RE: PCN # ESU270-32 -- SP1006-01UTG Backend Assembly, Test and Packing Location Transfer

Product/Process Change Notice (PCN)

PCN#: ESU270-32 **Date:** Oct 21, 2015

SP1006-01UTG of TVS

3.2 Material Changes

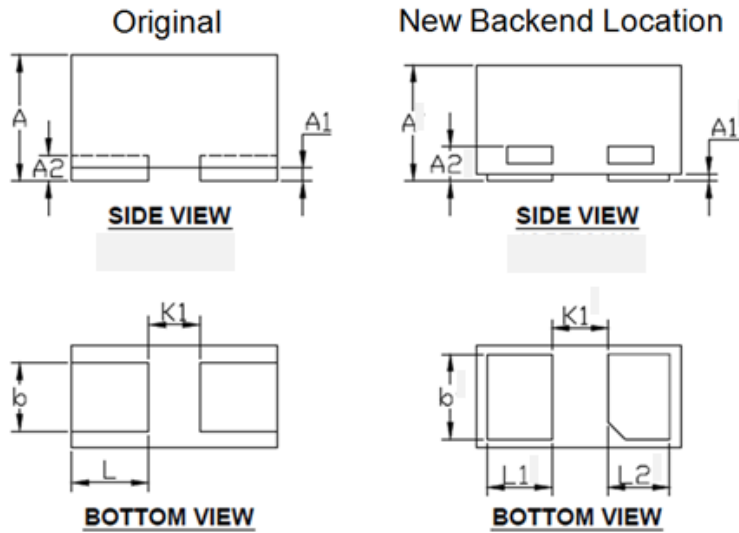
Material	SP1006-01UTG				Changed?
	Original		New		
	Material Name	Supplier	Material Name	Supplier	
Leadframe	EFTECT64T	ASM	EFTECT64T	ASM	No
Die Attach Material	CDF200	HENKEL	8008MD	HENKEL	Yes
Au Wire	20um	TANAKA	20um	KangQiang	Yes
Molding Compound	CELL9220HF13H	Hitachi Chemical	GE-300LCF	SUMITOMO BAKELITE	Yes
Wafer	LFZE105A		LFZE105A		No
Lead Finish	Ni,Pd,Au	ASM	Matte Tin	Tianshui Long Bo	Yes
